From: [Keyon, David](#)
To: [Gerry Haas](#); [Andy Wang](#)
Cc: [Bethany Windle](#); [Hill, Shannon](#); [Downtown West Project](#)
Subject: Re: Downtown West review
Date: Tuesday, April 13, 2021 5:57:52 PM
Attachments: [BOSTON PROPERTIES Final SSE.pdf](#)
[App B-2 Riparian Setback Assessment.pdf](#)

CONDITION 11 EXCEPTION REQUEST

Date	April 5, 2021
Subject	Stream and Riparian Setback Condition (Condition 11) Exception for South Almaden Office Project (Boston Properties), City of San Jose (#SP20-005)
Recommendation	No Recommendation
Reviewed By	Gerry Haas, Conservation Planner

Subject: Biological Assessment Regarding Presence / Absence of Riparian Habitat, Delmas Mixed Use Project Site, San José, California

Figure 5. FEMA Floodplain Boundary, Delmas Mixed Use Project Site, San Jose, CA

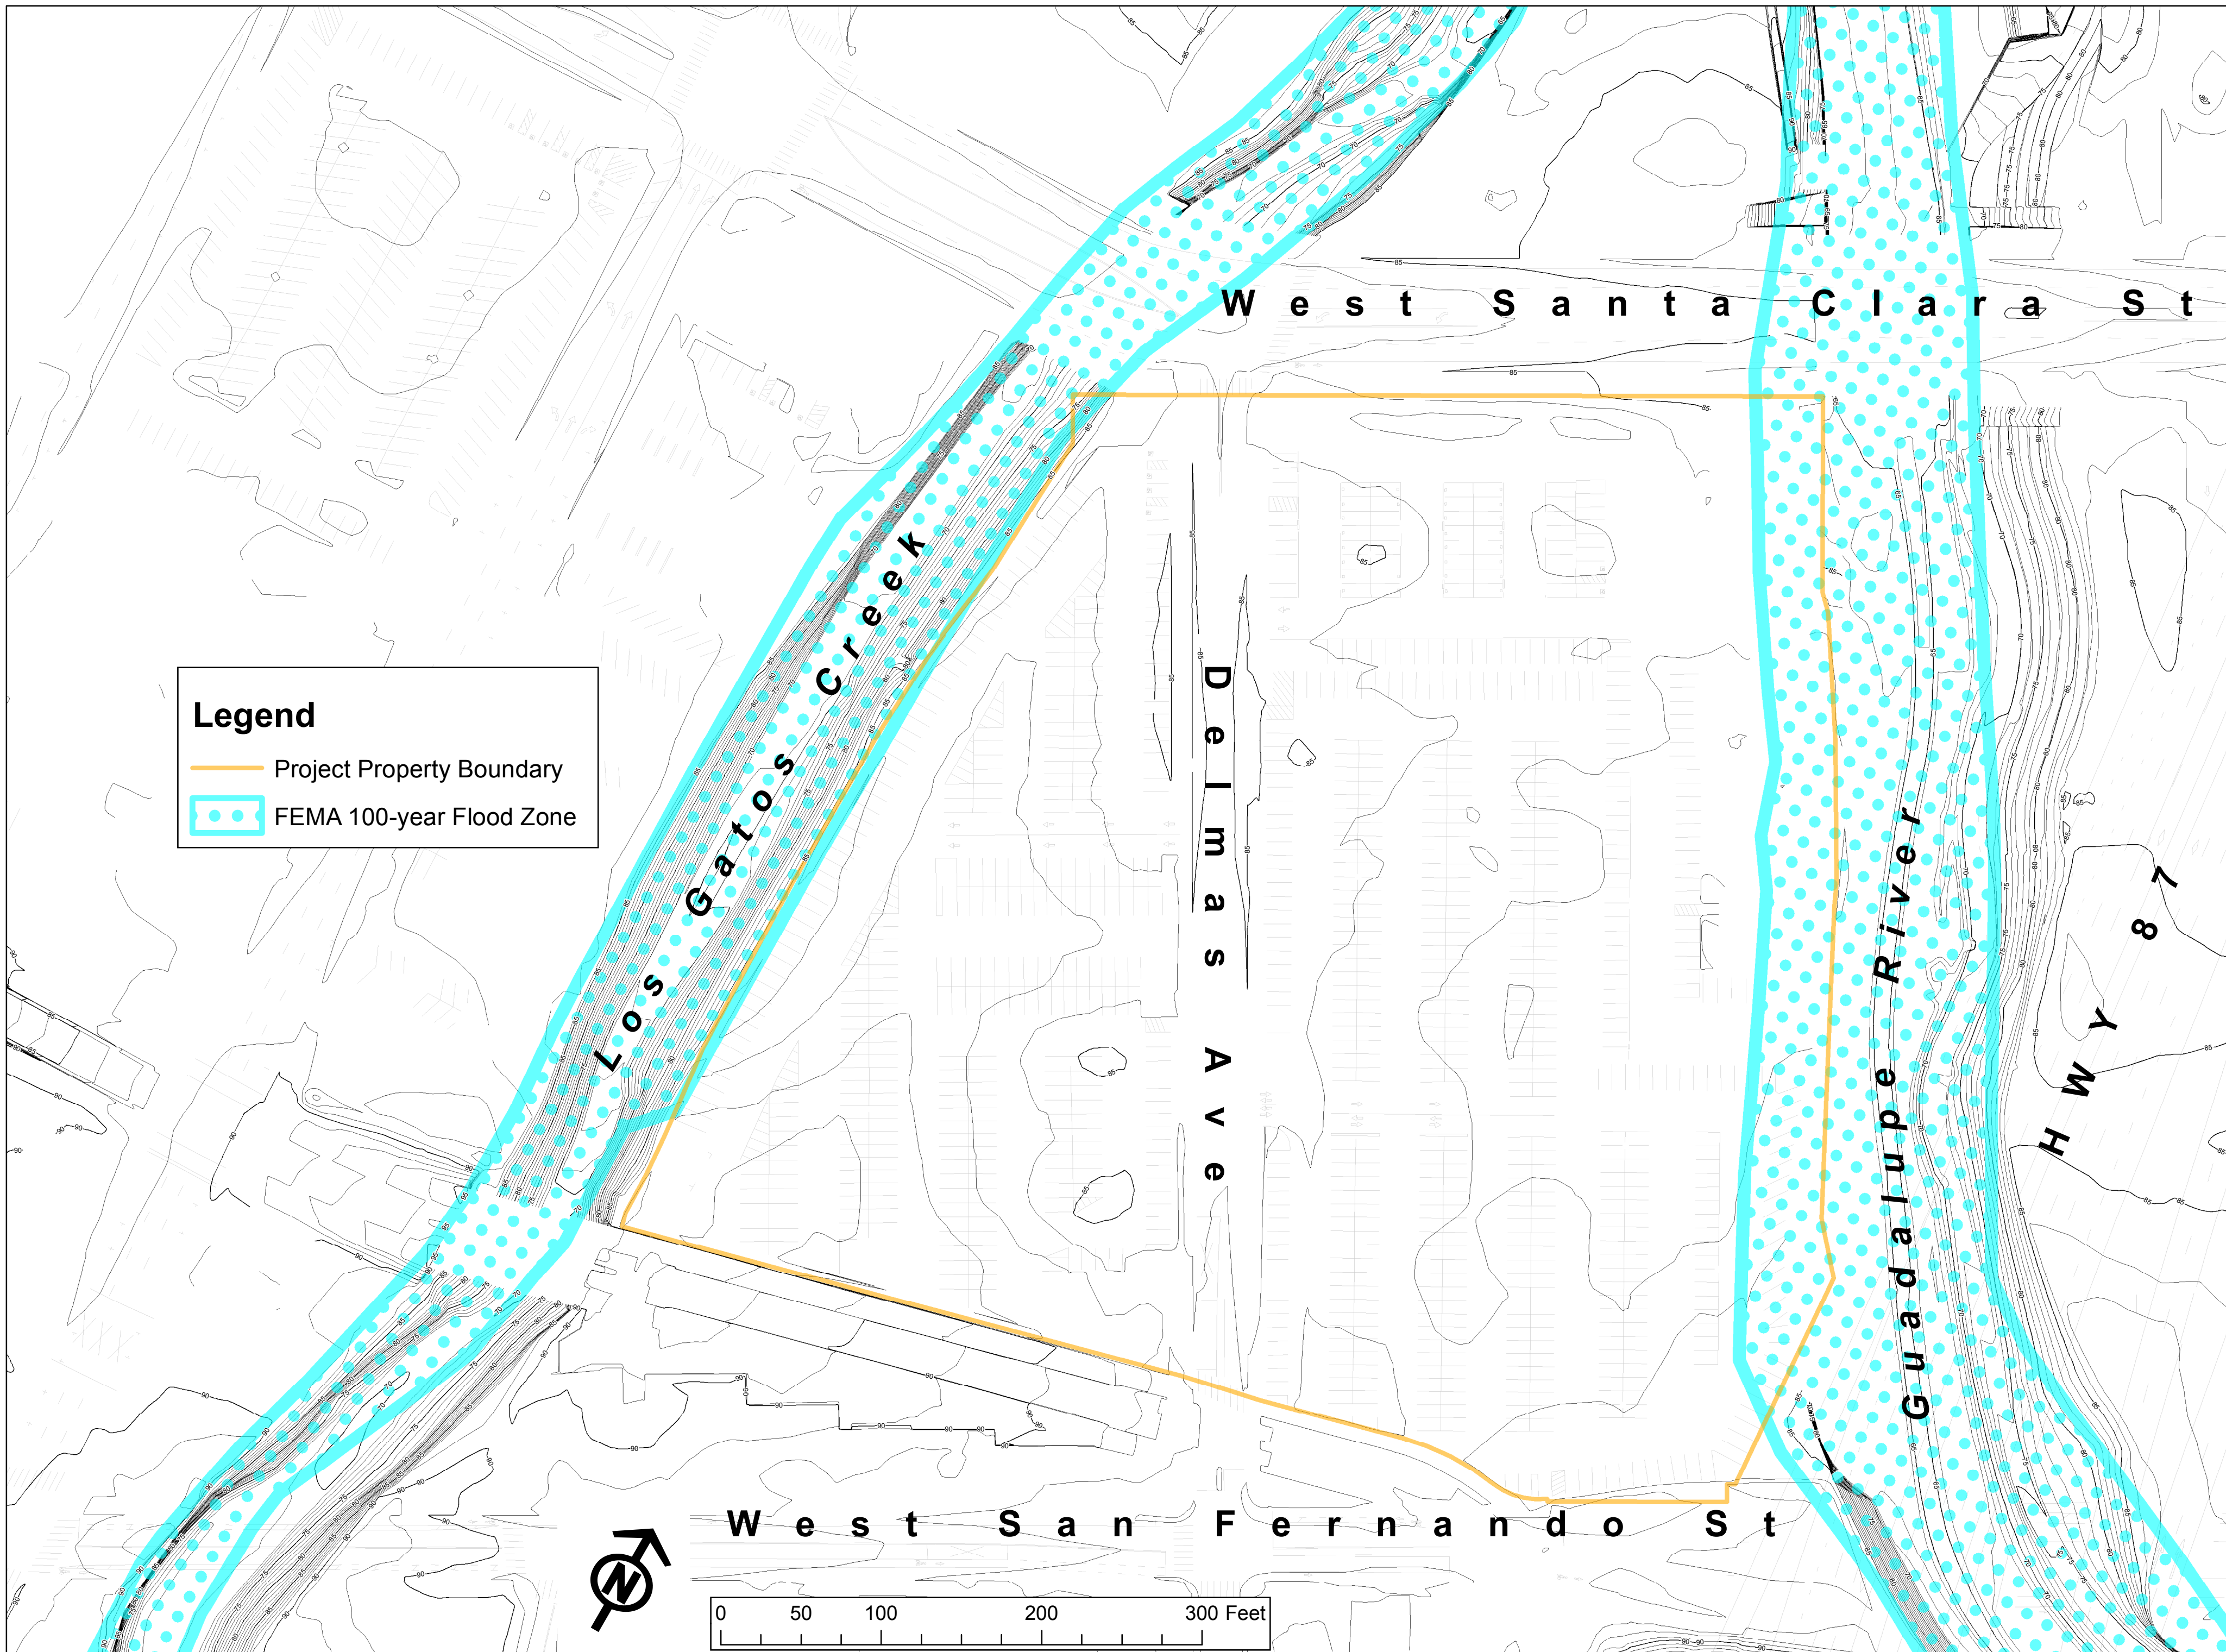
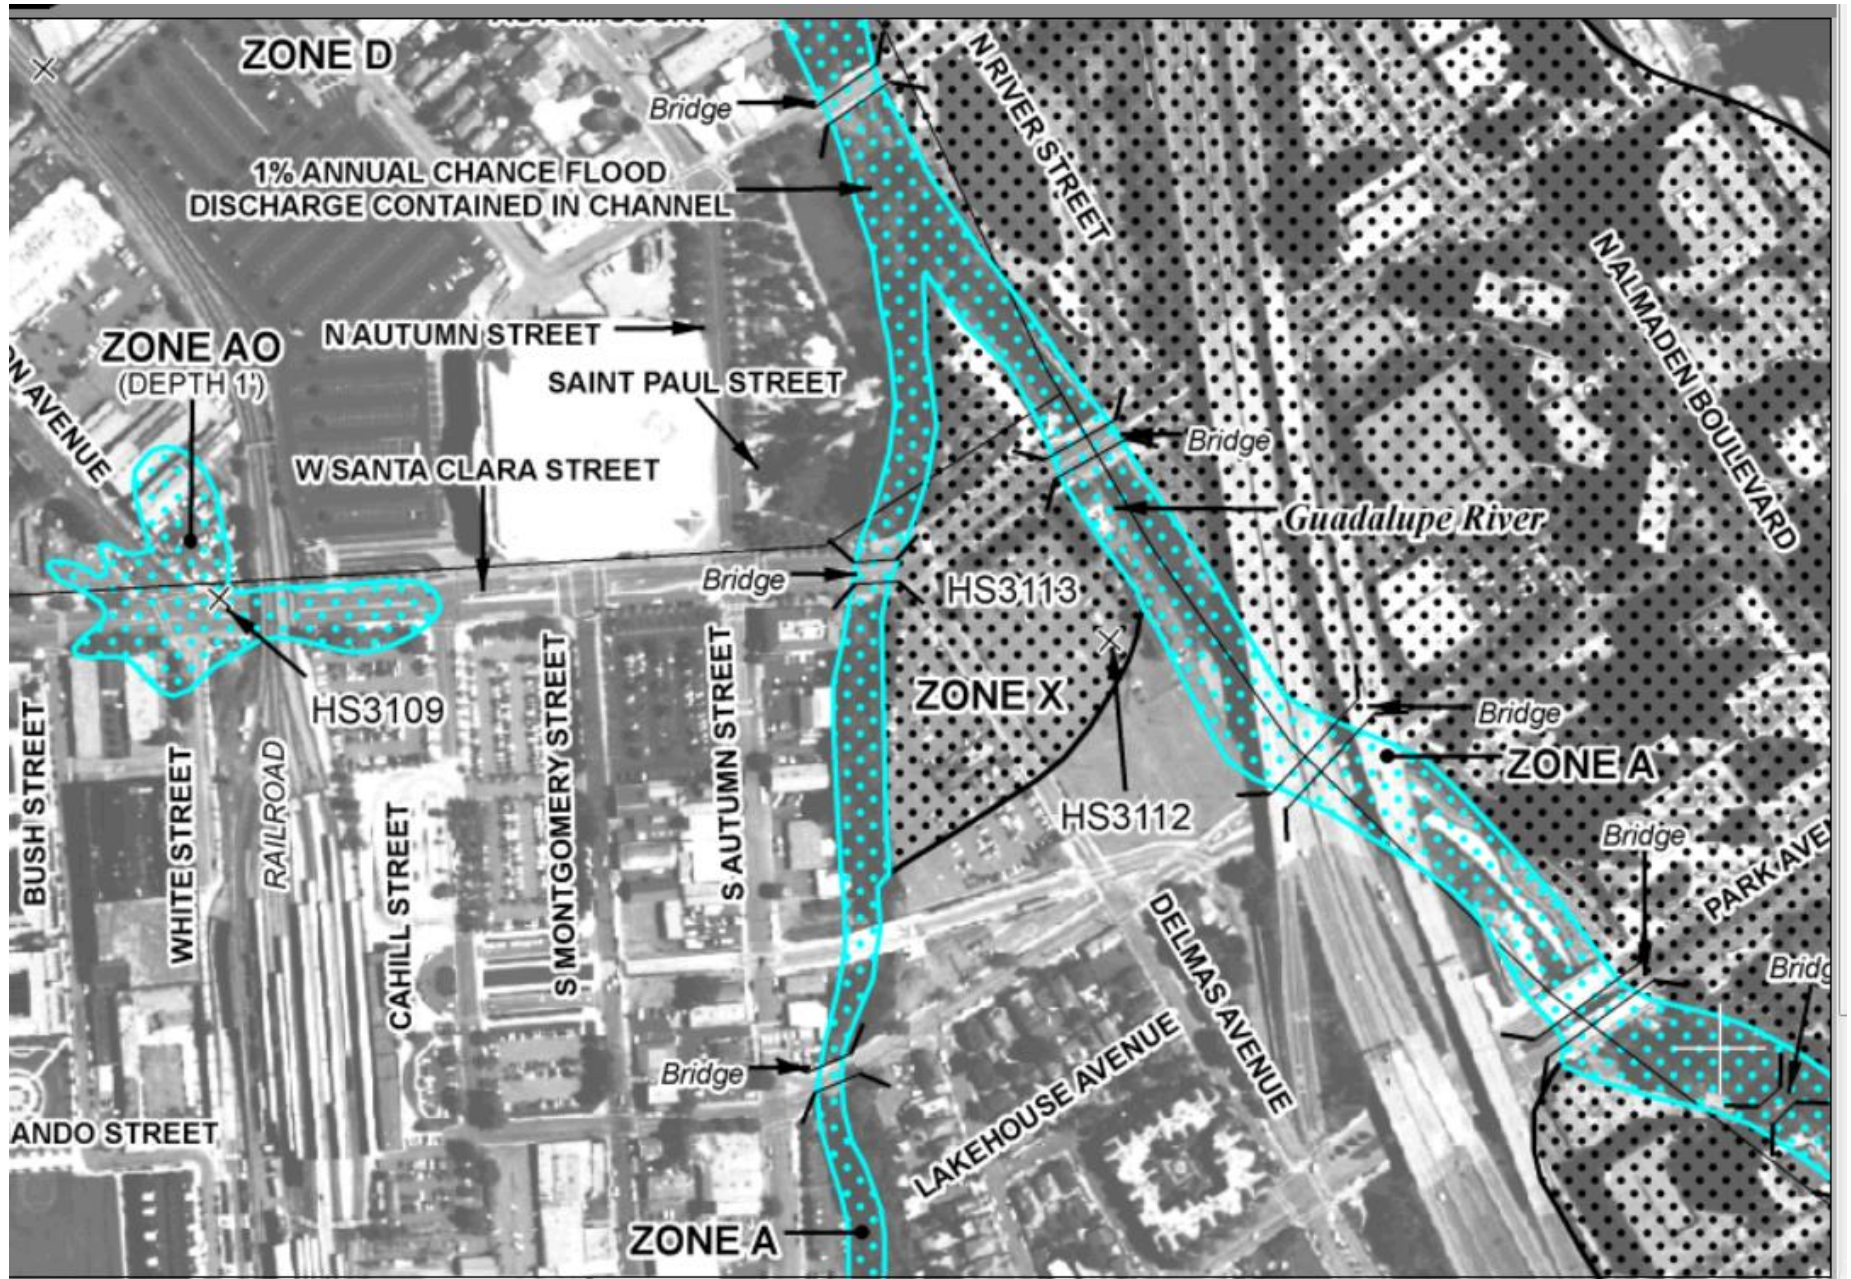
FEMA Mapping. FEMA mapping on Figures 5 and 6 illustrates that the Guadalupe River segment adjacent to the Site will contain a 100-year flood within the channel. Figure 5 shows that the Zone A 100-year floodplain is mapped as extending onto the eastern fringe of the Site from the Guadalupe River; however, the Flood Insurance Rate Map (Figure 6) has the following note: "1% annual chance flood discharge contained in channel" (FIRM 06085C0234H, May 18, 2009). The northern portion of the Site is in flood Zone X, the zone between the limits of the 100-year and 500-year floods; the southern part of the Site is not shown to be within any flood zone (Figure 6). Given the Site's location atop the retaining wall, the associated channel improvements to this segment of the river for flood control, and the corresponding notation on the FIRM that Zone A flood discharge would be contained in the channel, the potential for flooding onsite appears to be *de minimis*, which further substantiates the lack of riparian conditions on the Project Site.
